WEST END REGIONAL NAVIGATION CENTER PROJECT
BID NO.: DE-26-222-SB

Addendum No. 2 Information
June 16, 2026

4.1 **Revised** "WEST END REGIONAL NAVIGATION CENTER" Plan Sheets are hereby included and shall replace the previously released "WEST END REGIONAL NAVIGATION CENTER" Plan Sheets. Changes to Plans include:

P402

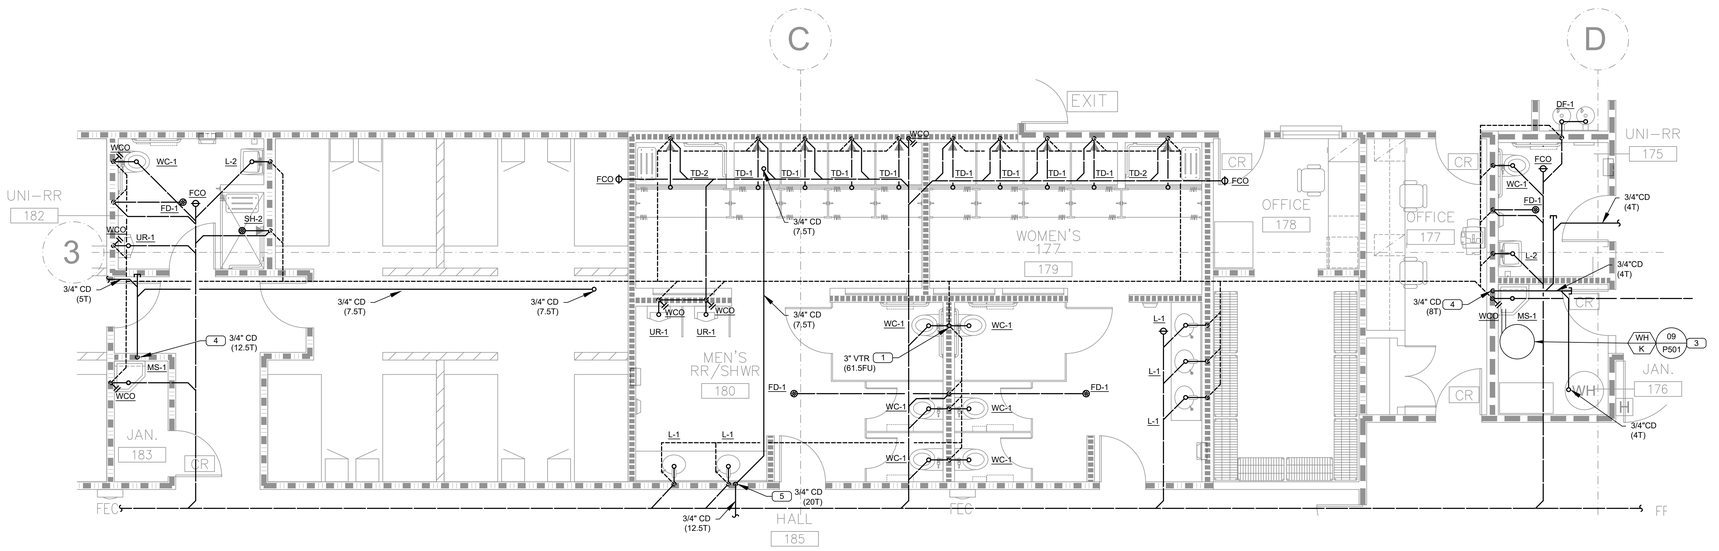
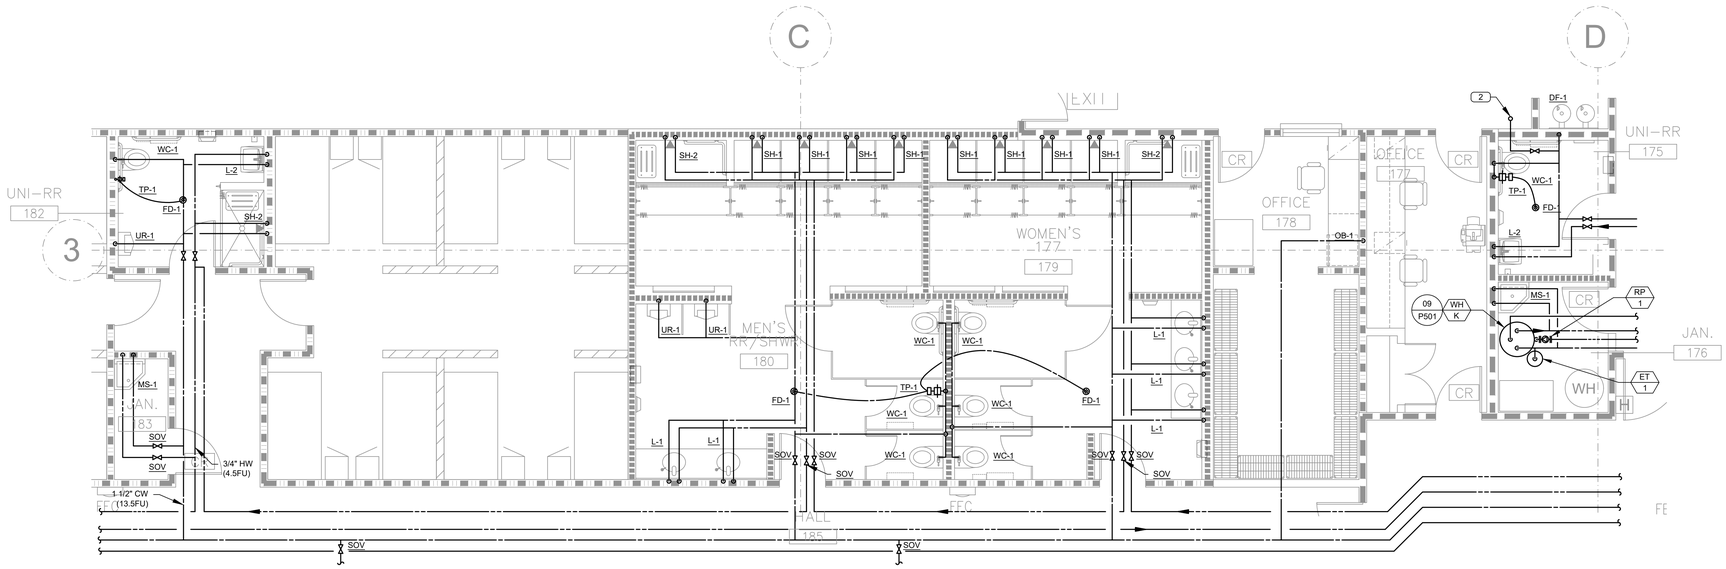
nnn. **Sheet P402:** Revised General Note #20 to be 2025 code cycle.
ooo. **Sheet P403:** Revised General Note #20 to be 2025 code cycle.
ppp. **Sheet P404:** Revised General Note #20 to be 2025 code cycle.
qqq. **Sheet P405:** Revised General Note #20 to be 2025 code cycle.
rrr. **Sheet P406:** Revised General Note #20 to be 2025 code cycle.
sss. **Sheet P501:** Revised notes 8-13 in detail to reference 2025 code.

E201

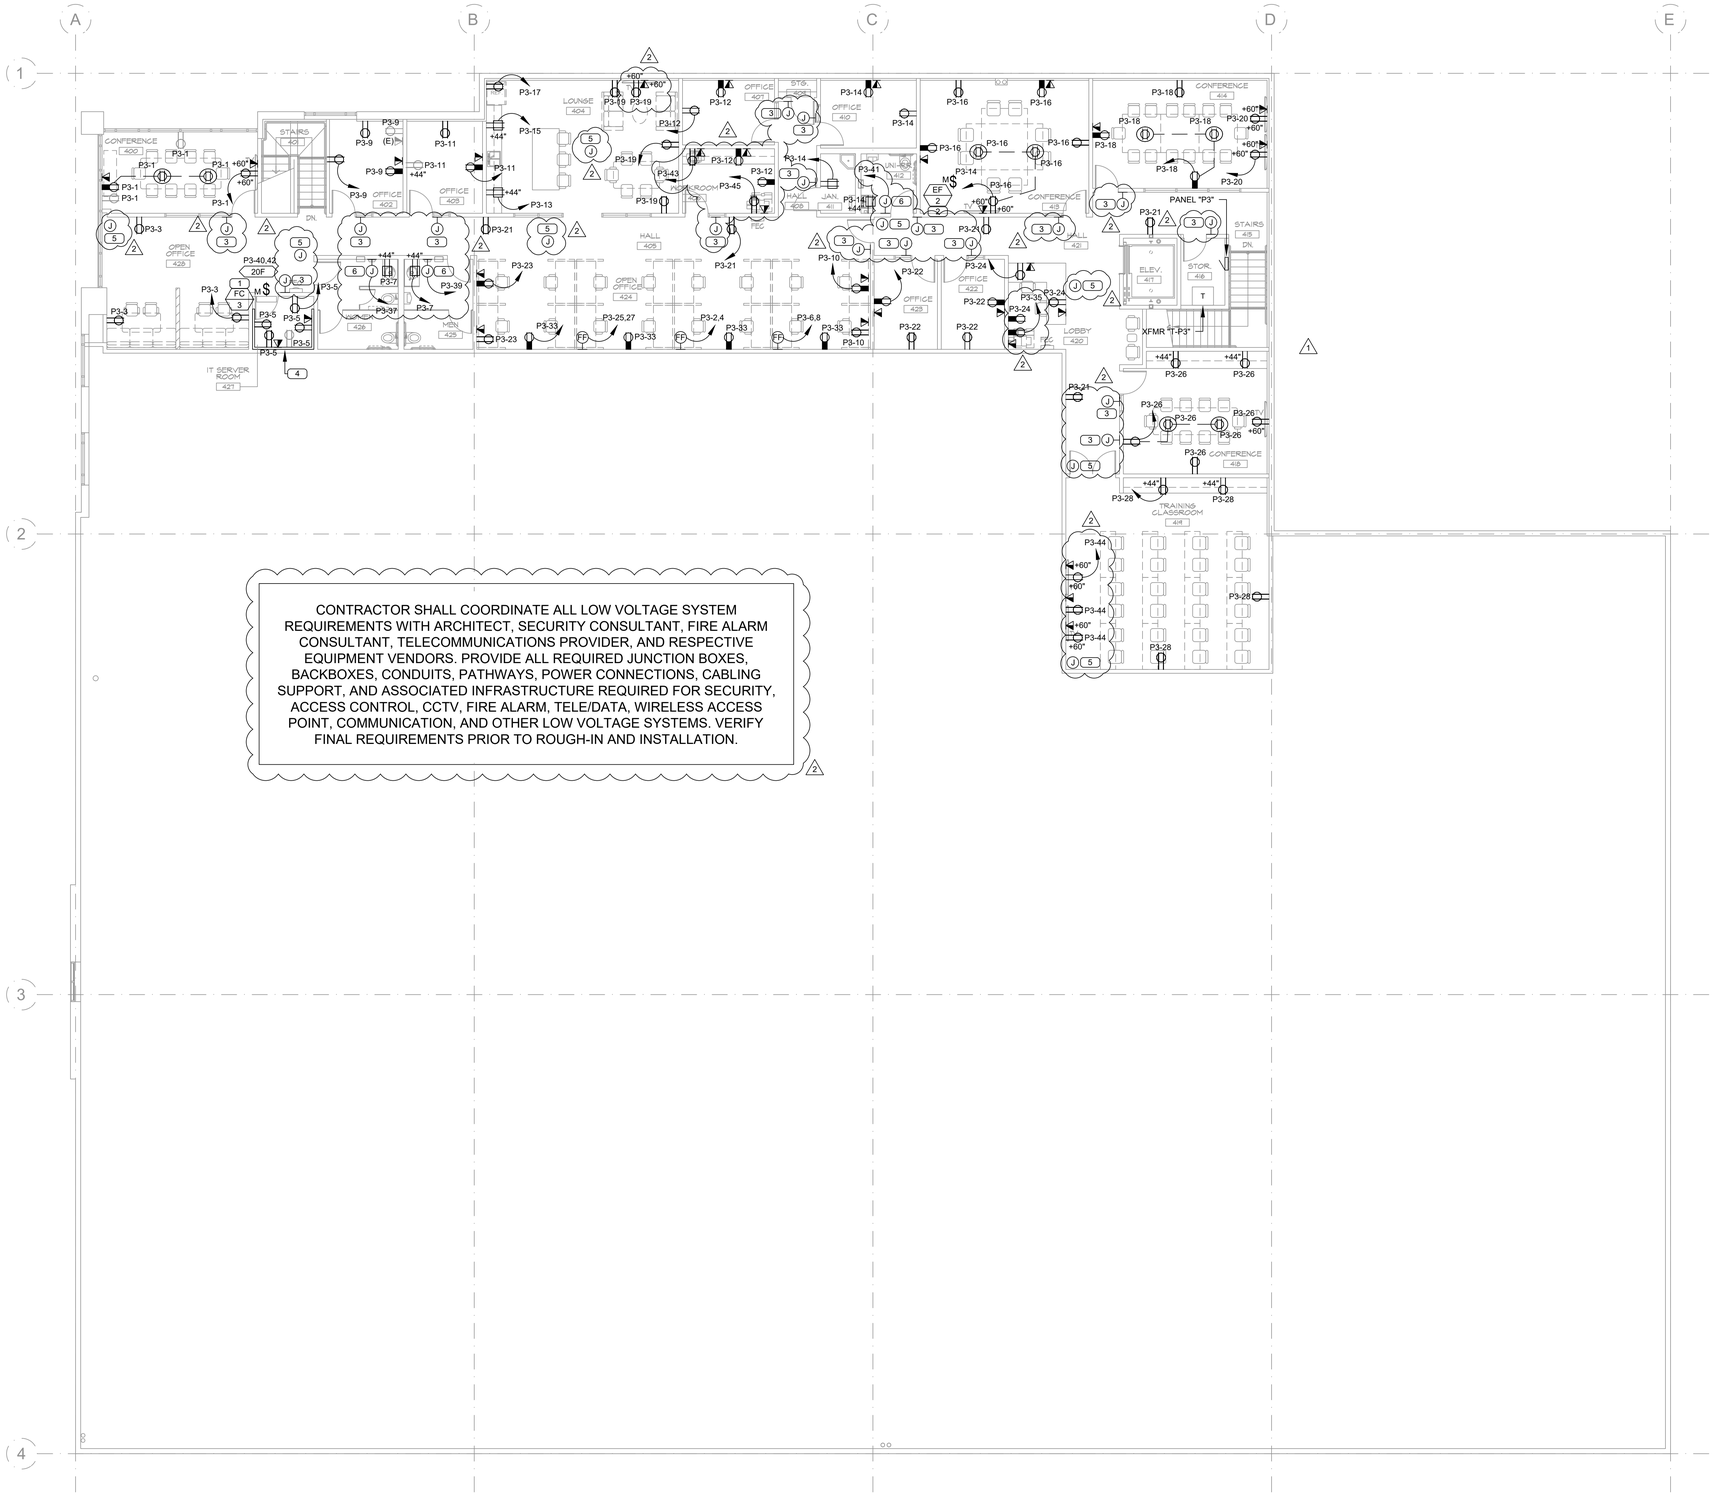
bbbb. **Sheet E201:** Revised Dorm Rooms 186, 187, and 188 to reflect reconfiguration into four smaller dormitory rooms. Revised power distribution associated with the new dormitory room layout. Reconfigured laundry room equipment layout to align with latest architectural drawings and selected equipment. Revised branch circuiting and panel assignments associated with updated laundry equipment. Added card reader locations coordinated with security drawings. Added CCTV camera junction box locations coordinated with security drawings. Added power connections for (2) metal detector stations. Added Solatube daylighting devices with associated electrical connections and controls. Added power connection for hand dryer equipment. Added provisions for assistive listening system infrastructure to support CBC

11B-219 accessibility requirements. Added power provisions for mobility dorm room accessibility devices and communication systems in accordance with CBC 11B-809 requirements. Added miscellaneous power devices including televisions and printers. Added coordination keynotes for security, accessibility, and specialty systems. Added keynote requiring verification and upgrading of existing receptacles with GFCI protection where required by CEC 210.8(A). Increased Transformer T-1 and Panel P1 capacities to accommodate revised connected loads. Refer to Sheet E501.

E211

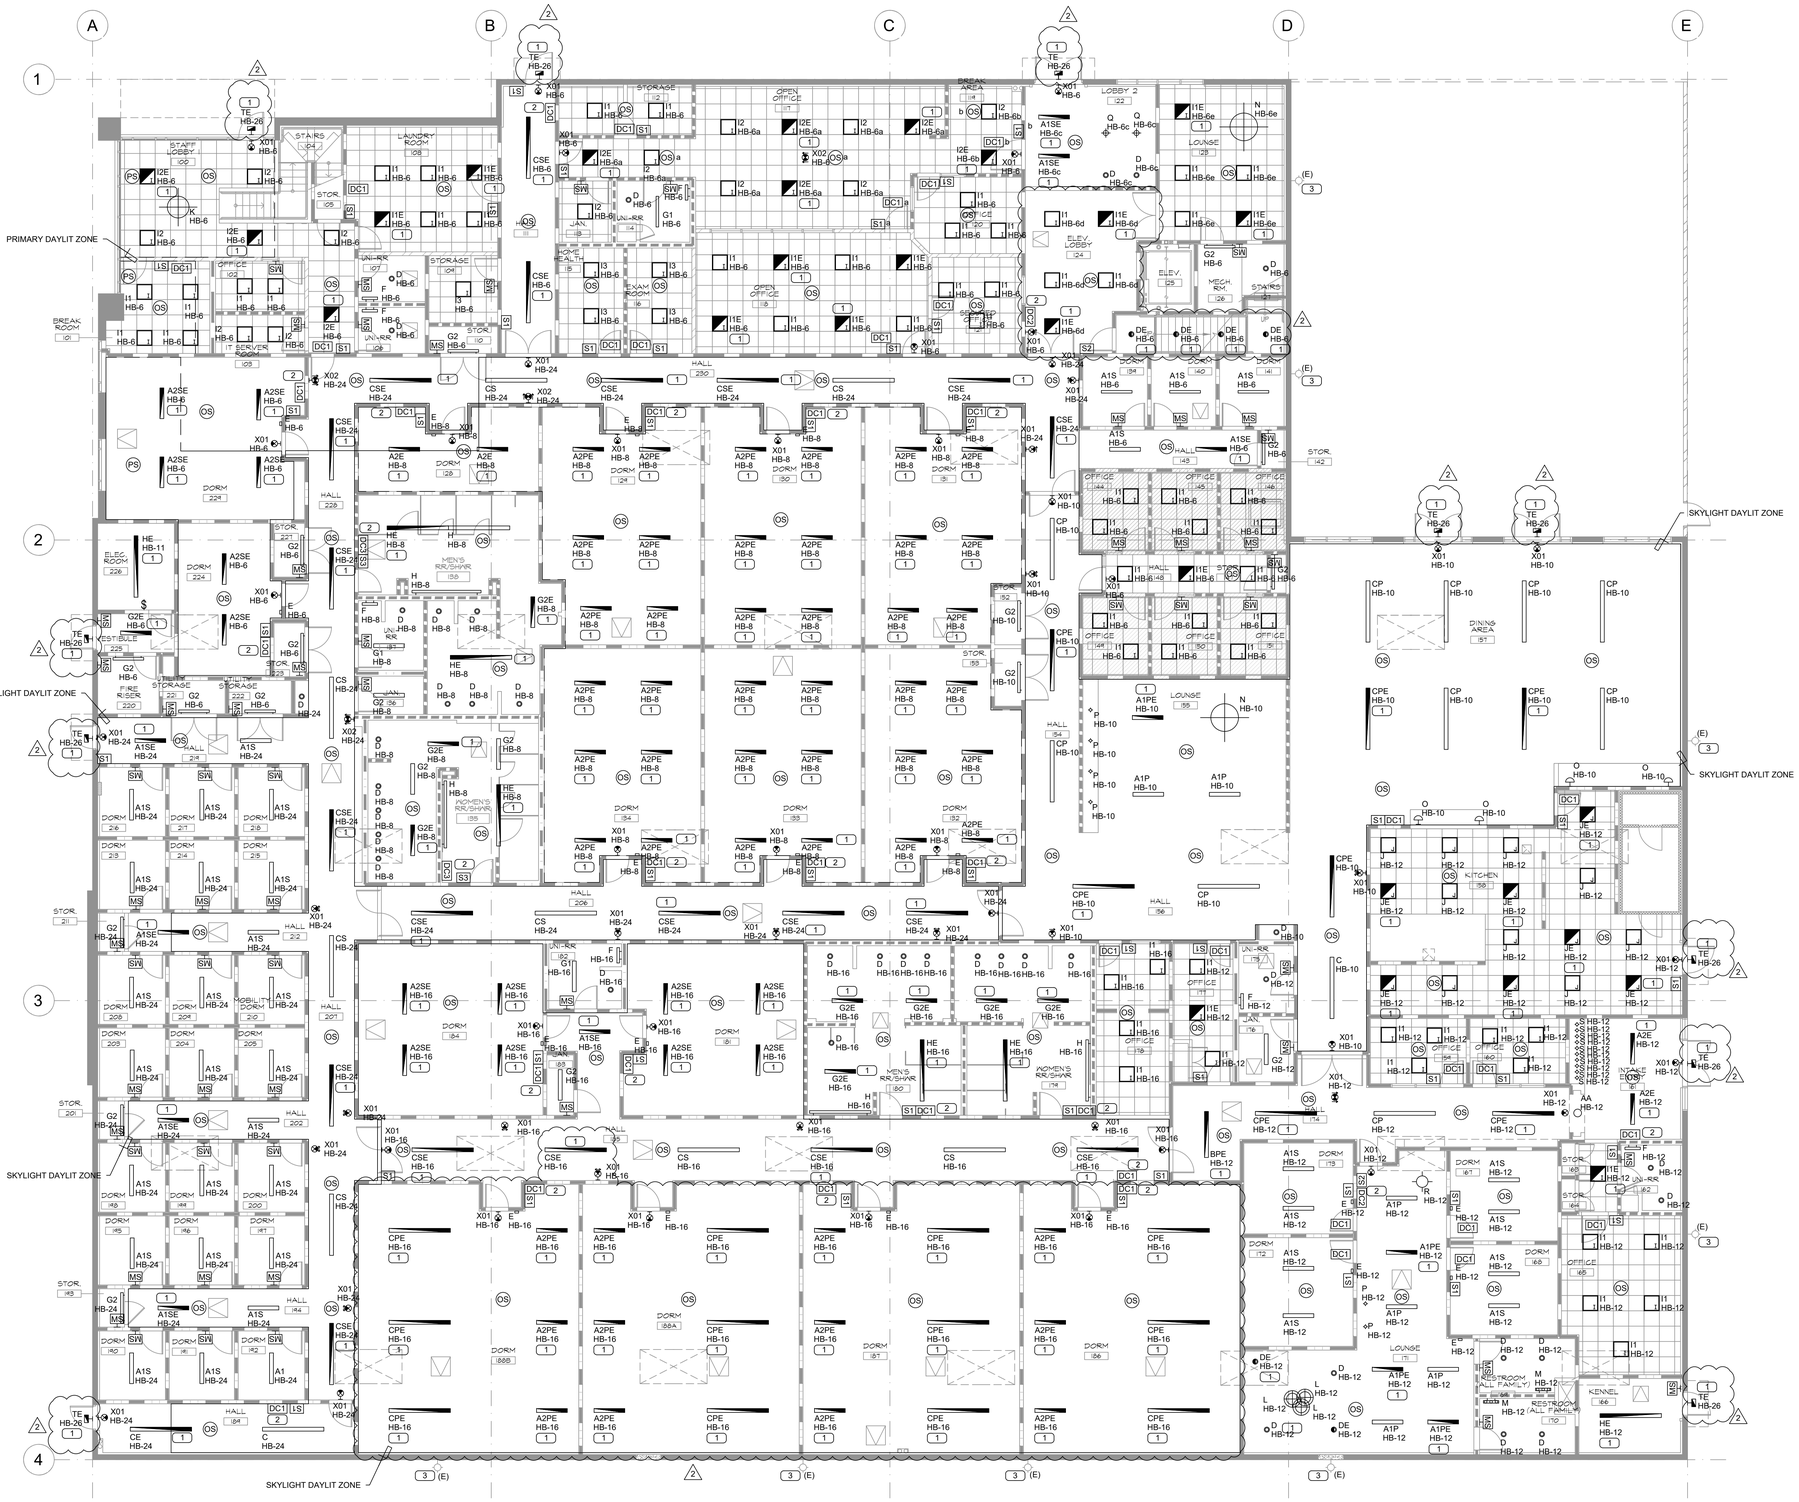
dddd. **Sheet E211:** Added HVAC control wiring keynote for thermostat and control system coordination.

E301

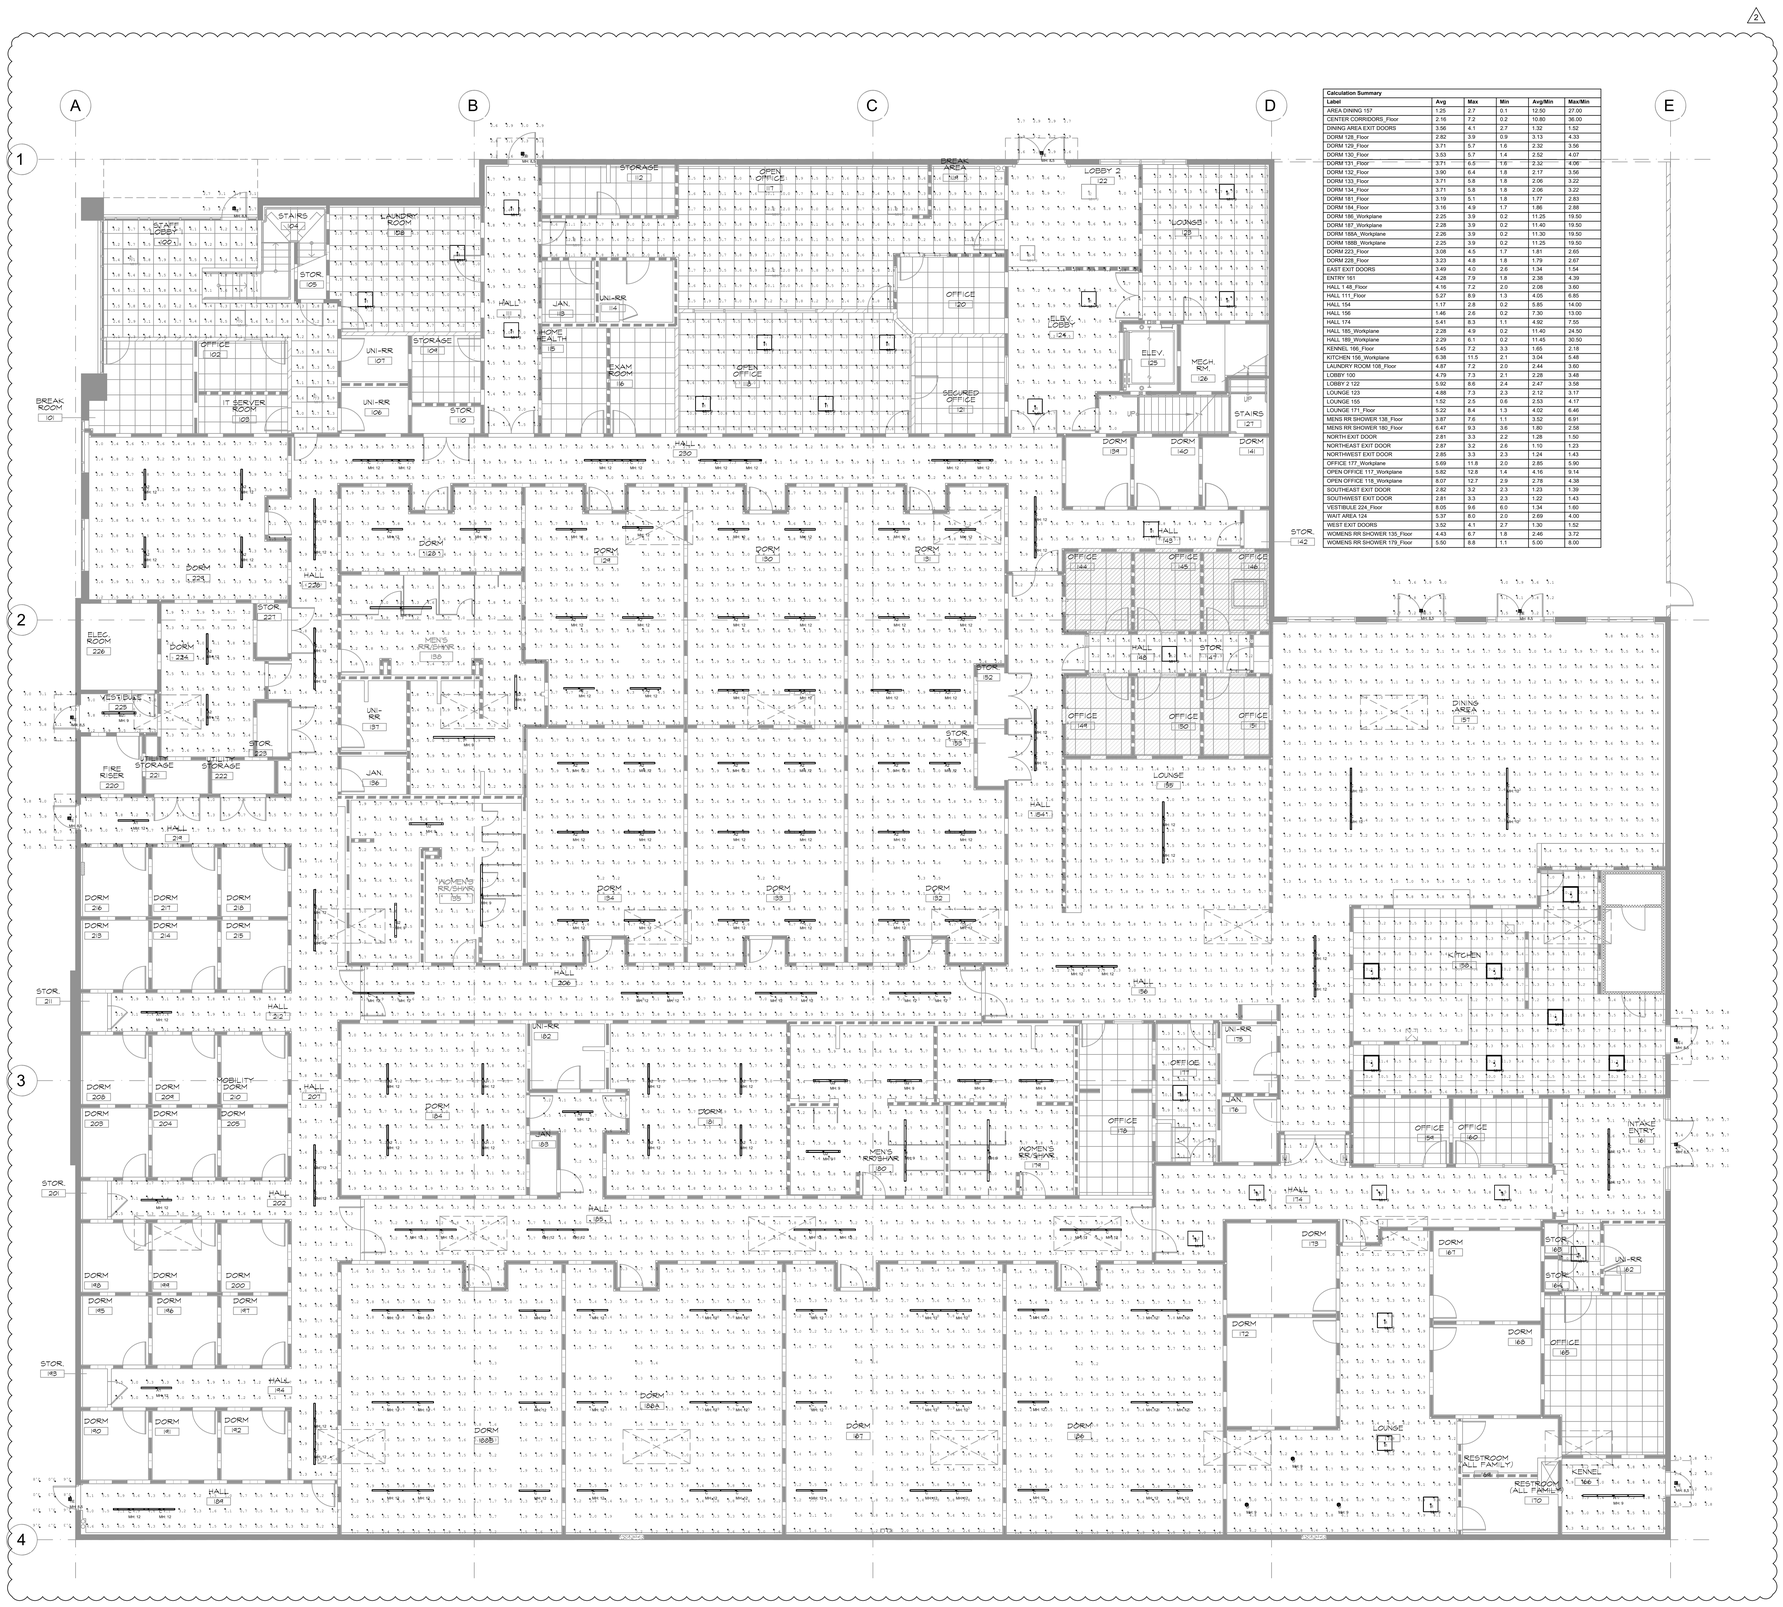
eeee. **Sheet E301:** Revised lighting layout associated with reconfiguration of Dorm Rooms 186, 187, and 188 into four smaller dormitory rooms. Revised lighting layout associated with stairwell modifications at the northeast portion of the building and adjacent Elevator Lobby 124. Added exterior emergency wall-mounted fixture type "TE" at required exit door locations. Updated emergency lighting design to maintain compliant egress illumination throughout required exit discharge paths. Coordinated lighting revisions with updated architectural floor plans.
